Bristol Airport
A38 Junction Improvements
Walking, Cycling and Horse Riding Assessment and Review
(WCHAR)
October 2018

NSC Highways and Transport - Pre-application Comments

A38 Junctions with Downside Road and West Lane, Lulsgate Bottom, North Somerset

Stage 1 Road Safety Audit

Client	Bristol Airport				
Project	Bristol Airport 12MPPA Masterplan				
Title					
A38 Junction Improvements Option 10					
Original Scale 1:500@A0	Drawn By TO	Date 24/10/18	Checked By DR	Auth CC	
Drawing Number C1124-SK-A38-010					Rev 9.0

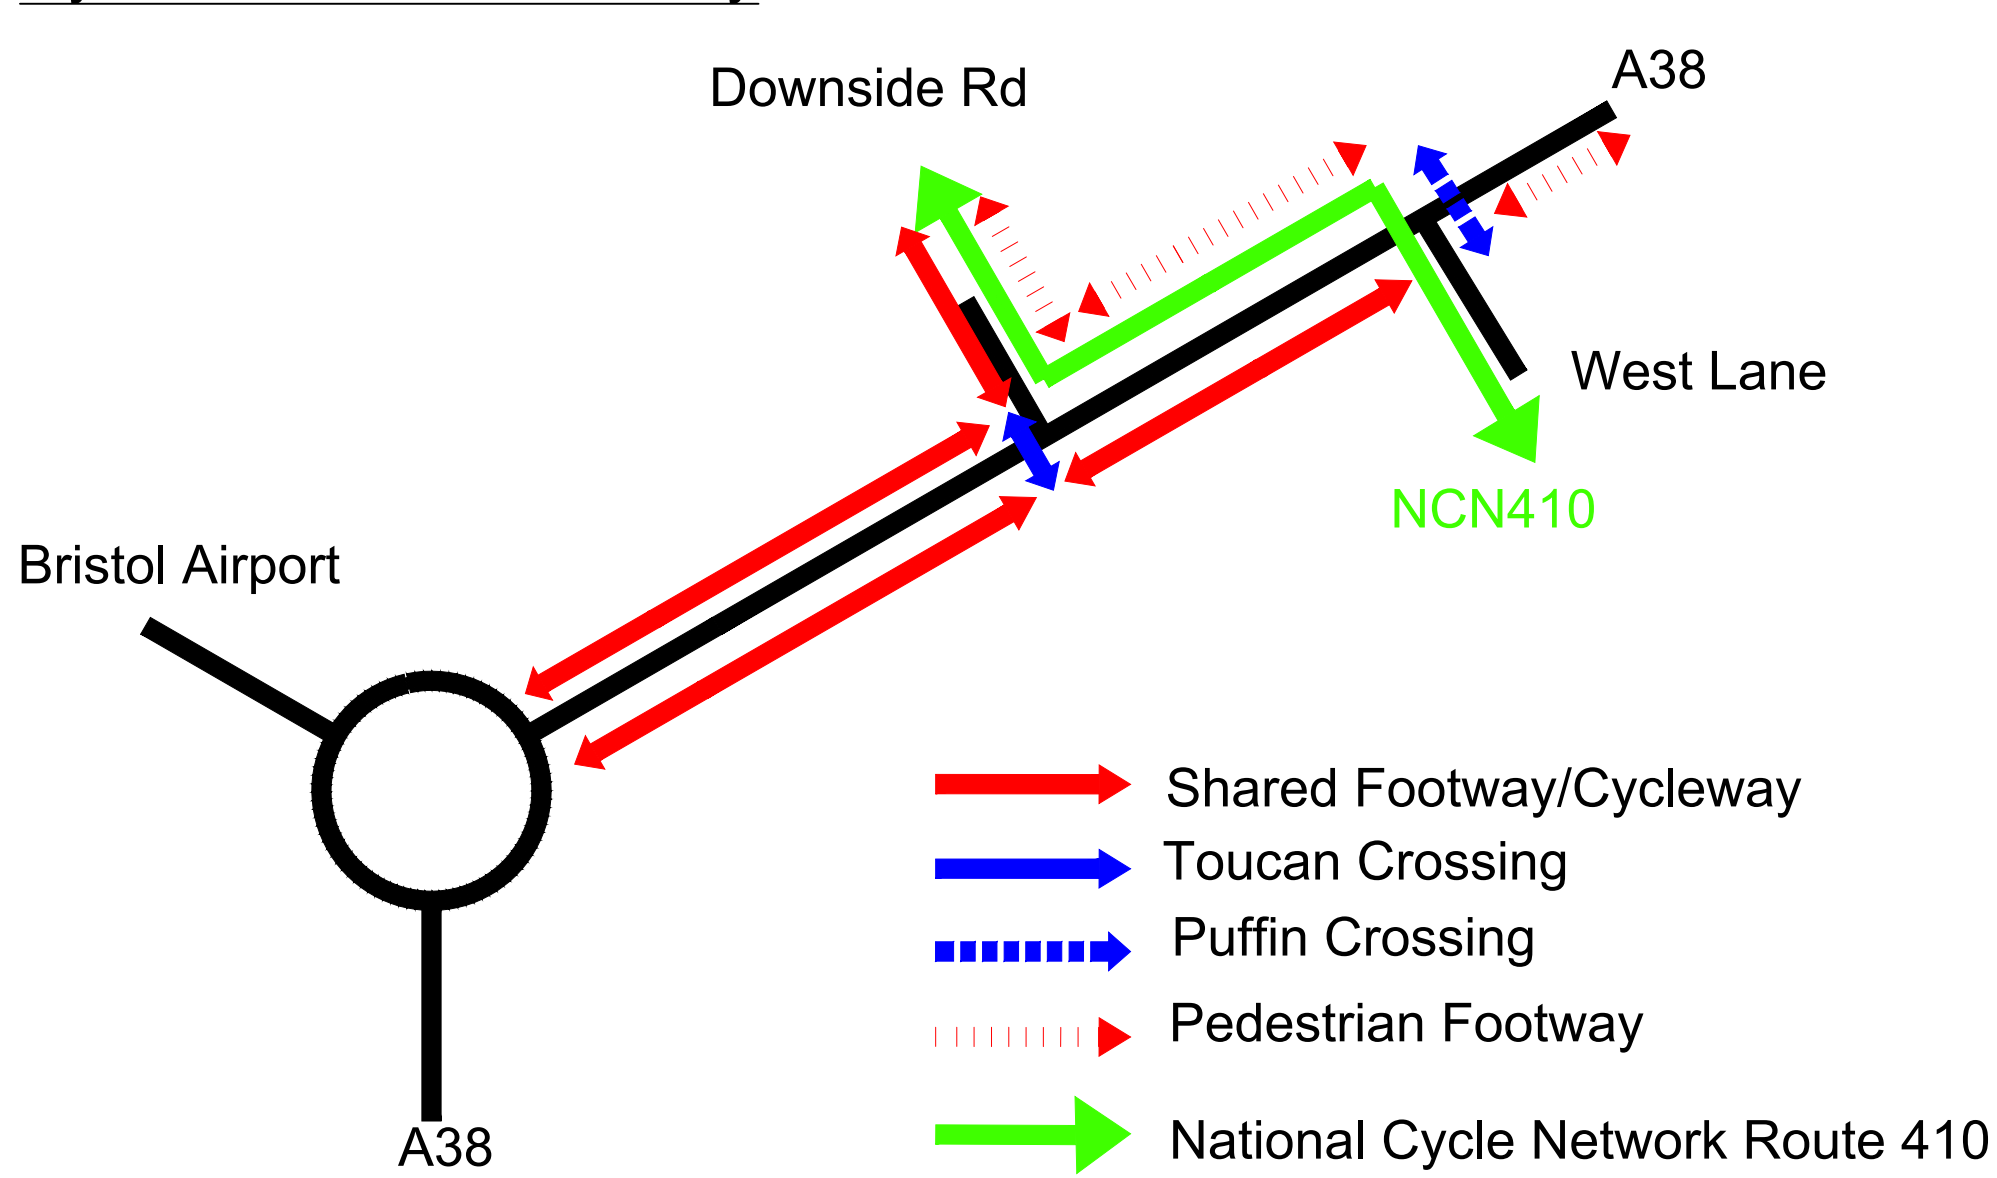
Recommendation: It is recommended that the forward sightline is sufficient for actual traffic speeds and for the predicted queue lengths.

Problem: It is not clear which footways are shared-use.

3.4	Yes	Yes	Noted. A review of the Automatic Traffic Counts has indicated the actual 85th percentile speeds for the southbound approach is 41.2 miles per hour. Based on the SSD calculations set out within DMRB this equates to a SSD of 106.6 metres, which has been shown on the on Drawing C1124-SK-A38-010 Rev 9.0 to demonstrate that these sightlines can be achieved.

3.8	Yes	Yes	For confirmation, a pedestrian / cycle facility diagram has been included on Drawing C1124-SK-A38-010 Rev 9.0. In addition to this, additional labels and ladder and tramline tactile paving have been added to denote the shared footway / cycleway facilities.

These comments have been produced based on plan titled A38 Junction Improvements Option 10 Drawing No.C1124-SK-A38-010 Rev 2.0

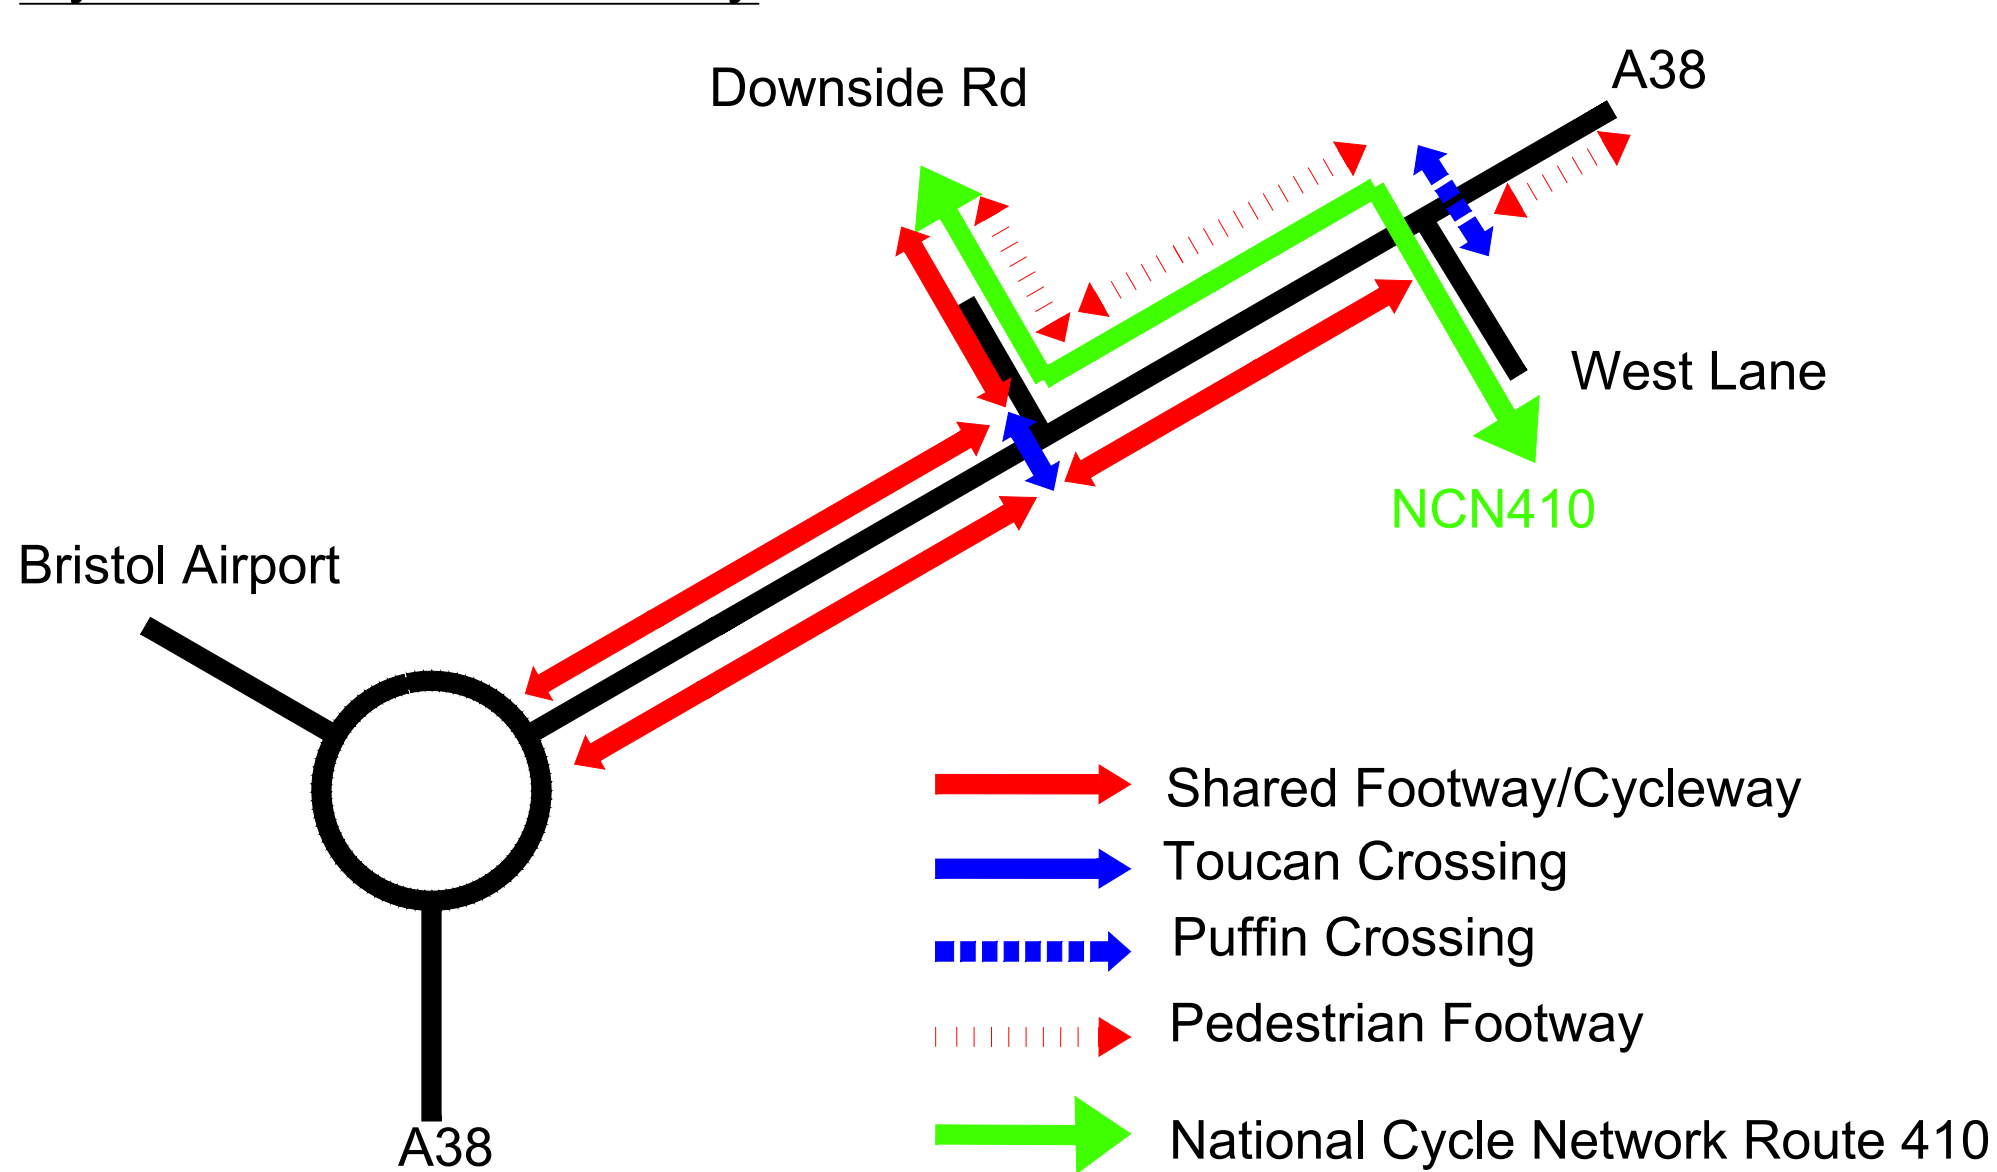
- The green line does not match with North Somerset Council (NSC) records for the adopted highway. For example, NSC records indicate the adopted highway only extends to the back of the footway on the east side of the A38 opposite the Downside Road junction.

- We would wish to see further details of the proposed access to the existing Airport Tavern public house. The new access may require alterations to the internal layout of the car park, and details such as this will need to be submitted to ensure vehicles can easily enter and exit the premises and not create a new road safety issue on Downside Road. Furthermore, tracking plots should be provided which show delivery vehicles can make use of this access. We would like to see clarification on whether the A38 access for the pub will be stopped up.

- The proposals also seem to be removing car parking from the front of the pub – we will need to be satisfied that adequate parking will remain across the site and will not lead to any parking on the public highway.

- All private access points need to be shown on plan. Vehicle tracking is needed for private accesses. How will servicing of premises along route be achieved?

- The proposed scheme does not provide any details of pedestrian and cycle crossing facilities such as dropped kerbs and tactile paving.
- The design needs to accommodate cycle route NCN 410 Avon Cycleway. New sections of shared path on west side of A38 appears to be under 3.5m wide. It would be useful to clarify which parts are shared use and what entry and exit points are. Consider providing advance stop lines and feeder lanes. Sustrans should be consulted by the designers.

- The gap in hatching on Downside Road is approx. 2m wide. Not wide enough for a ghost right turn lane this may result in rear end shunt type collisions.

- Swept path analysis needed for all highway movements. Right turn out of Downside Road looks very tight as does right turn into West Lane.
- On A38 north-bound and Downside Road there are 2no. lanes approx. 3m wide. Actual lane widths should be provided across the scheme together with swept path analysis to enable us to judge whether these are sufficient.

- Lane marking will need to be reviewed and may need changes on roundabout. Consideration of how lane marking will affect road safety and capacity.
- North bound bus stop near the Airport Tavern is not in a lay by. The operation of this stop will need to be considered (i.e. frequency of services layover) and we will need to understand the impact this has on safety and capacity.

- **Plan** is option 10 - can we see other options? Signalised junction at West Lane will need to be justified.

A.1 Appendix A – Location Plan

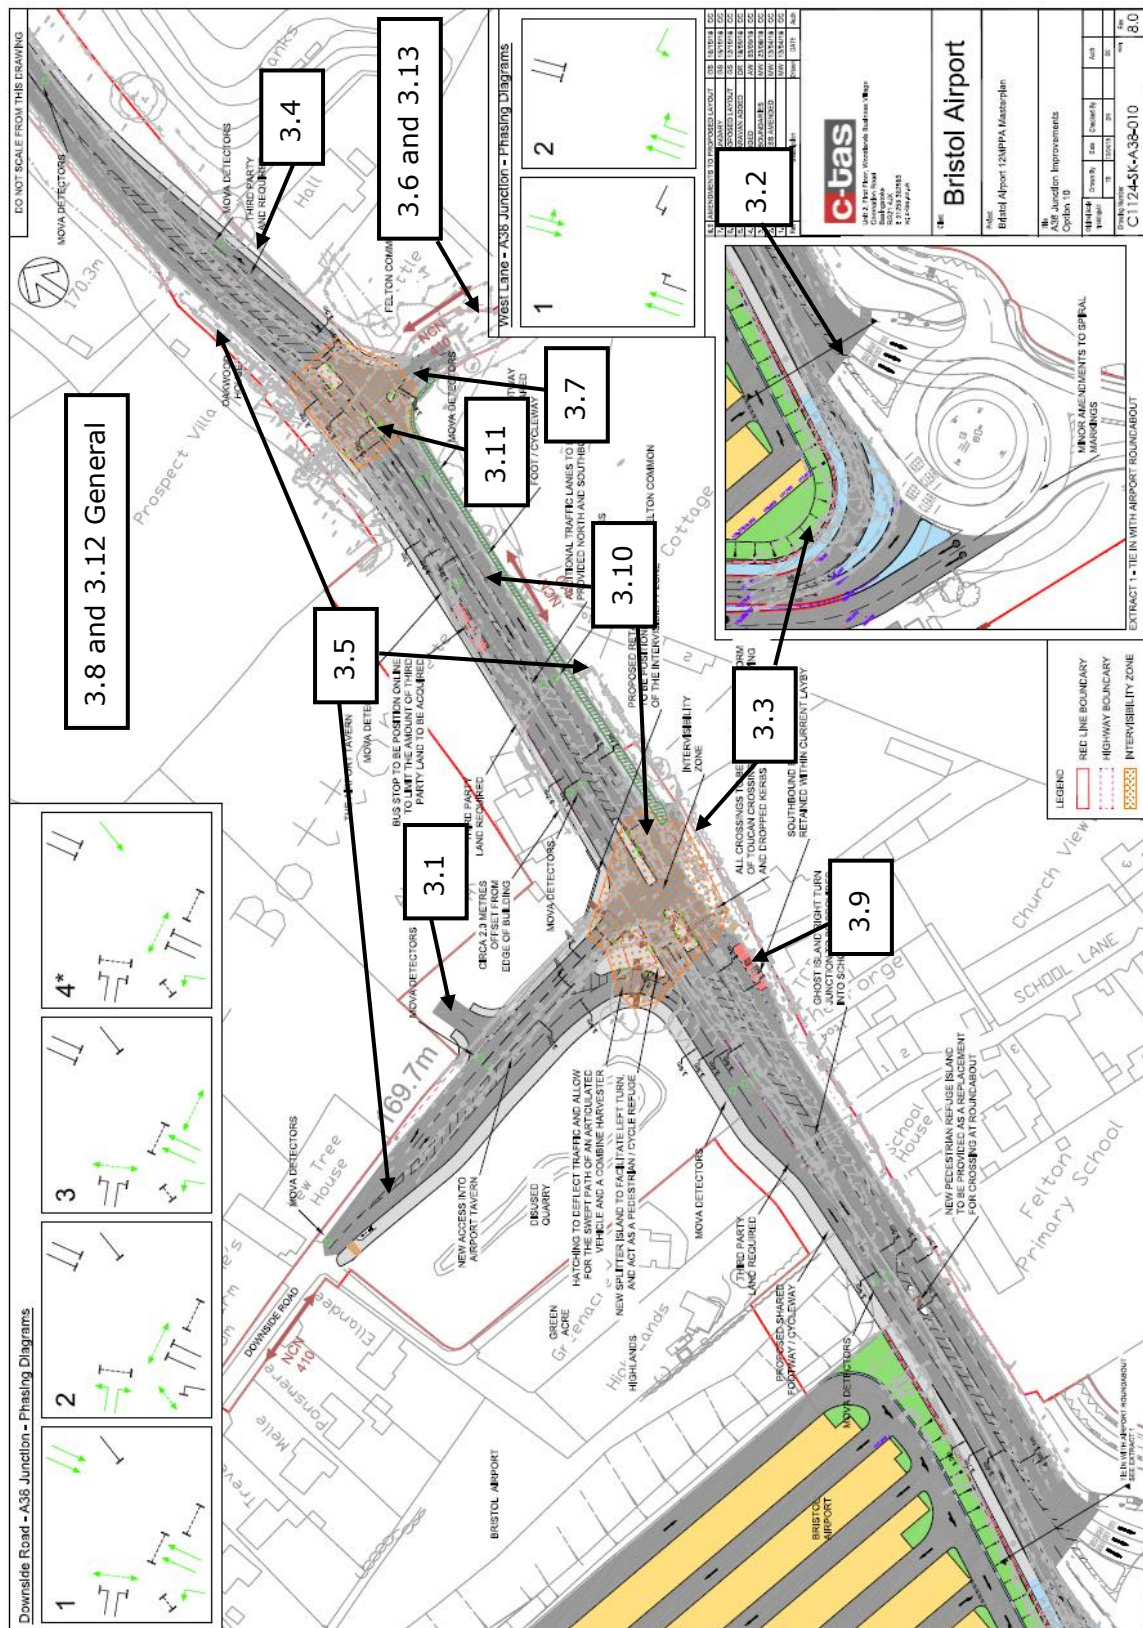
- 3.1 **Location:** The northern side of Downside Road close to the junction with the A38.

Problem: Steep gradient at proposed access to the Airport Tavern.

A new vehicular access is proposed to the Airport Tavern and there is a significant level difference between the road and the car park. If there is a steep gradient at or near the give-way line then this could restrict sightlines or result in problems when emerging, resulting in risks of collisions with traffic on Downside Road.

Recommendation: It is recommended that the gradient is minimised so as to ensure sufficient sightlines and to ensure that traffic emerges onto Downside Road from a suitably level approach.

- 3.2 **Location:** The existing uncontrolled pedestrian crossing near the airport roundabout.

Problem: There is a notable desire line at this point and the proposal is to close this crossing.

A new crossing point is proposed about 100m to the north of the roundabout, but pedestrians are notoriously reluctant to deviate from the most direct route and it seems highly likely that crossing movements will continue near to the roundabout. The proposal includes the addition of a filter lane, or segregated left-turn lane, and the deletion of the dropped kerbing and tactile paving. Consequently, pedestrians who cross at this point will be at increased collision risk.

It is recommended that this pedestrian movement is either prevented or provided for. Prevention could include the provision of extensive pedestrian guard railings on both sides of the road. Alternatively, a suitable additional pedestrian crossing facility could be provided for pedestrians crossing the new filter lane.

- 3.3 **Location:** At the roadside generally, but particularly alongside the new roundabout filter lane and to the east of the junction with Downside Road.

Problem: There are some significant level differences.

Recommendation: It is recommended that suitable assessments are carried out and that barriers are provided where necessary.

- 3.4 **Location:** The A38 to the north-east of West Lane.

Problem: The realignment of the carriageway could result in an increased risk of nose-to-tail collisions.

3.7 **Location:** The junction of West Lane with the A38.

Problem: There is no provision for pedestrian crossings across the newly signalised junction at West Lane.

The phasing diagram shows that there will be either a left-turn in, or a left-turn out, under all conditions. Pedestrians wishing to cross West Lane must therefore always do so in potential conflict with traffic that has a green light. Similarly, the northbound lane of the A38 will always show a green light and there is no provision for this pedestrian crossing movement.

It is recommended that suitable pedestrian provision is included for the crossings of the A38 and West Lane, possibly including a pedestrian refuge.

3.8 **Location:** General.

Recommendation: It is recommended that shared cycle/footways should form continuous routes and that they should be sufficiently wide and clearly signed.

3.9 **Location:** The south-west bound bus stop layby.

Problem: Buses overhanging the carriageway.

Recommendation: It is recommended that the bus stop is enlarged or otherwise modified so that stationary buses do not overhang the running lane.

3.10 **Location:** The A38 to the south of West Lane.

Problem: Traffic from West Lane that wish to turn right may undertake u-turns.

The proposal involves prohibiting the right-turn from West Lane. There is an alternative route involving a u-turn 350m to the south at the airport roundabout. However, if there are queues then some traffic may attempt u-turns at the Downside Road signals or at other unsuitable locations.

Problem No. in Safety Audit Report	Problem Accepted (Yes/No)	Recommended Measure Accepted (Yes/No)	Alternative Measure (Detail Description)
3.1	Yes	Yes	It is agreed that the gradient will be minimised where possible to ensure that sufficient sightlines and to ensure that traffic emerges onto Downside Road at a suitable level. Details of proposed levels will be confirmed as part of the detailed design process and provided to the auditor for consideration as part of a future Stage 2 Road Safety Audit. In addition to this, the proposed visibility splays to the left and right at this junction have been added on to Drawing C1124-SK-A38-010 Rev 9.0 as additional information. The visibility splays shown have been based on the recorded 85th percentile speeds recorded in the east and westbound direction, using the visibility splay calculator set out within

highlighted any accidents that are caused due to these changes in levels. The proposed changes alongside the new roundabout filter lane, it is proposed that a vehicle restraint barrier / roadside barrier will be provide along the back edge of the pedestrian footway at the top of the proposed embankment, as shown on Drawing C1124-SK-A38-010 rev 9.0. Details of proposed levels and protection barriers will be confirmed as part of the detailed design process and provided to the auditor for consideration as part of a future Stage 2 Road Safety Audit.

3.10	Yes	Yes	The associated impacts for the no right turn restriction at West Lane are to be completed by Peter Brett Associates as part of the Transport Assessment for the Hybrid Planning Application, for which the A38 Improvement scheme is an element of. Based on the results of the 2018 traffic surveys only 11 and 13 vehicles currently turn right from West Lane northbound along the A38 in the AM and PM peak hours respectively. For these users to continue to travel north along the A38, they will need to divert and u-turn at the Bristol Airport roundabout, if they do not decide to re-assign to an alternative route from the route origin to avoid to do so. The design of both the left turn from West Lane, and the southbound approach at the A38 / Downside Road junction has been designed to

along West Lane. It is not possible to achieve the increase the slight line distance as part of the proposal. Therefore, in order to mitigate this issue, and increase the awareness to driver about the approaching new traffic signals. It is proposed that: • All vegetation is cut back to edge of the highway boundary in order to maximize visibility around approaching bend. • Additional anti-skid surfacing to be provided on approach to the stop line. • Discussion with NSC over the potential to relocate the change of speed limit further along West Lane. • Provide adequate signage indicating tight bend, and new road layout ahead. Details of proposed these mitigation will be confirmed as part of the detailed design process and provided to the auditor for consideration as part of a future Stage 2 Road Safety Audit.
--	--	--	--
